To: T10 Technical Committee  
 From: Rob Elliott, HP (elliott@hp.com)  
 Date: 6 March 2008  
 Subject: 08-126r0 SPC-4 SBC-3 SAS-2.1 Power condition enhancements

**Figure 1 — Power condition state machine for logical units implementing the START STOP UNIT command**

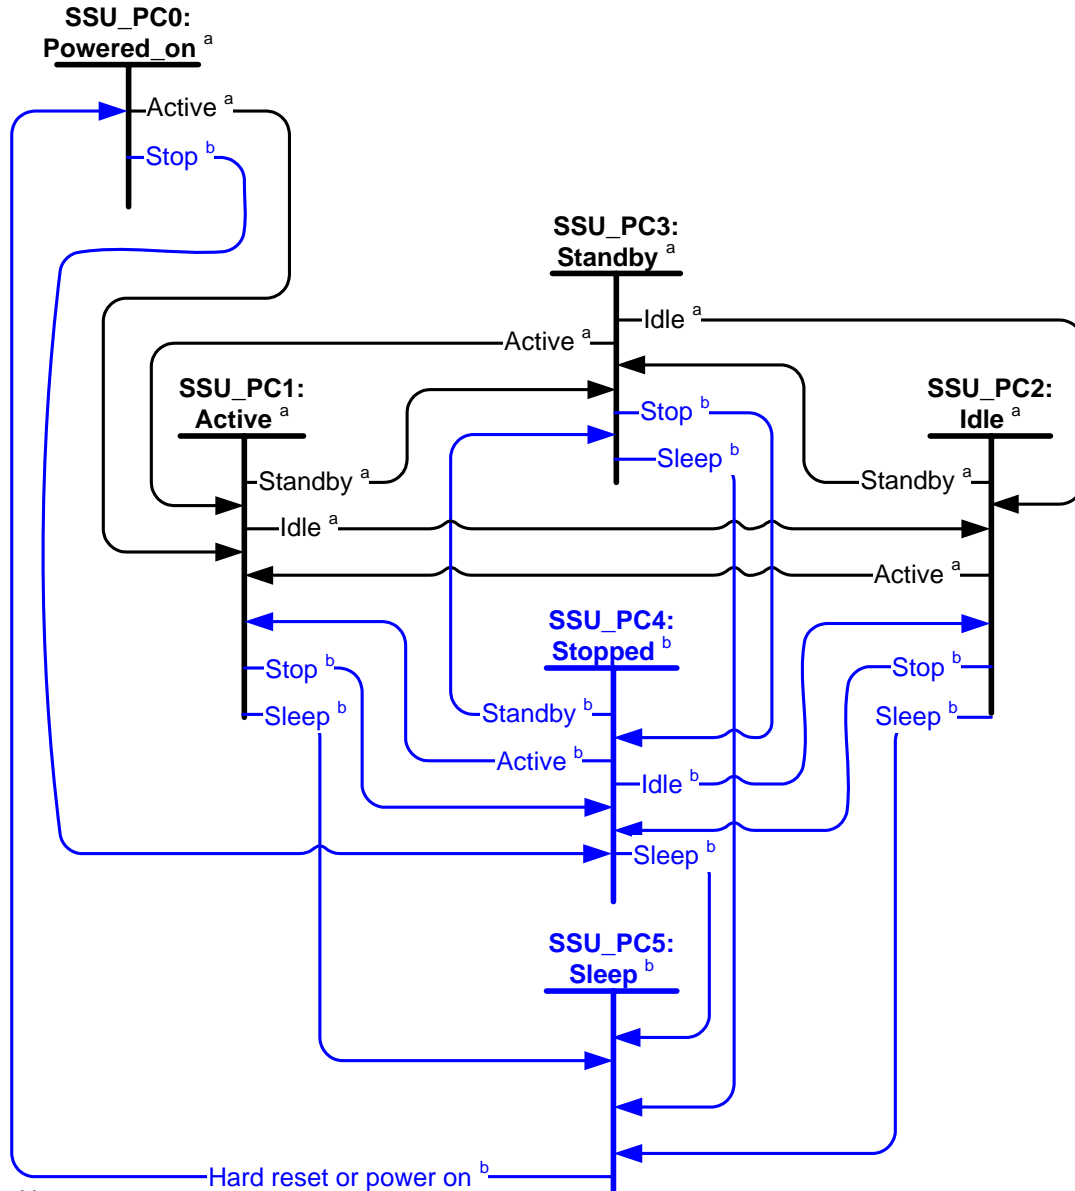
- a) SSU\_PC0:Powered\_on (see 4.16.2.2) (initial state);
- b) SSU\_PC1:Active (see 4.16.2.3);
- c) SSU\_PC2:Idle (see 4.16.2.4);
- d) SSU\_PC3:Standby (see 4.16.2.5); ~~and~~
- e) SSU\_PC4:Stopped (see 4.16.2.6); ~~and~~

f) [SSU\\_PC5:Sleep \(see 4.16.2.7\).](#)

Figure 220 — SA\_PC (SCSI application layer power condition) state machine for SAS [\[updated\]](#)

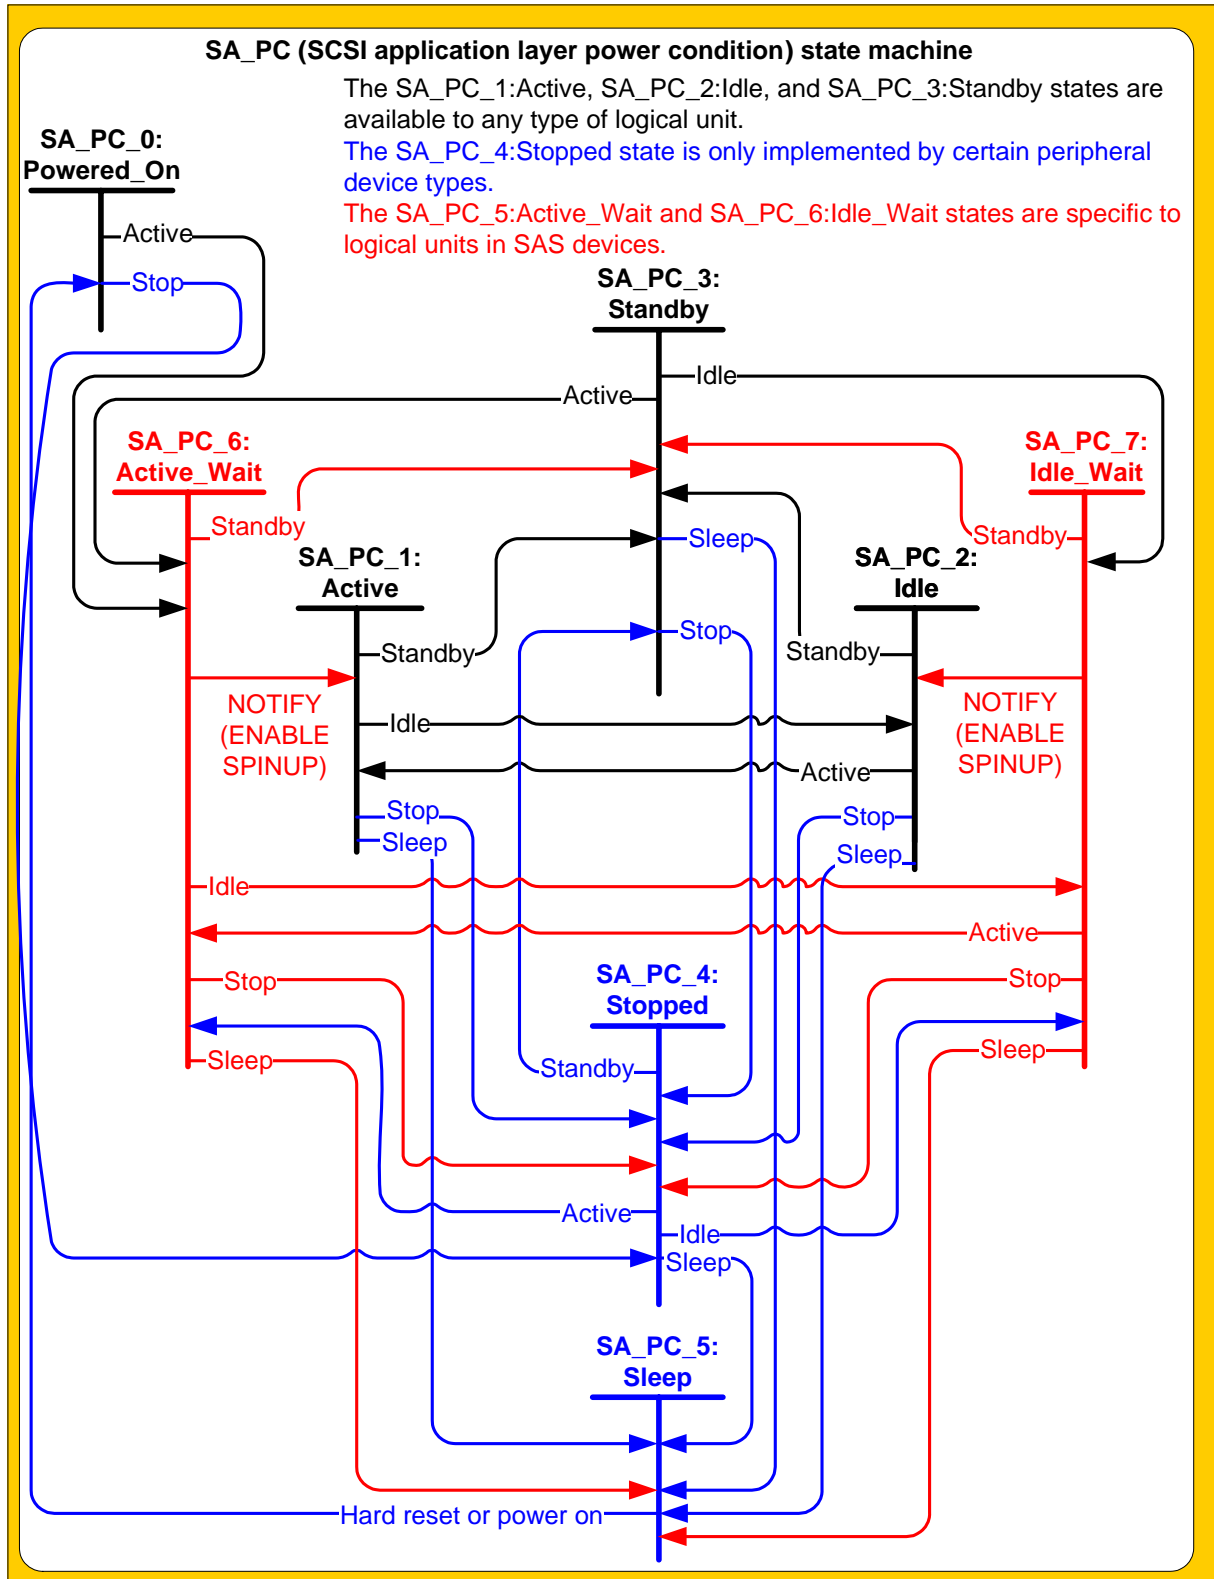
If the device server processes a START STOP UNIT command (see SBC-3, [MMC-6](#), or [RBC](#)) with the IMMED bit set to one, it may complete the command before completing the transition, if any, specified by the POWER CONDITION field and the START bit.
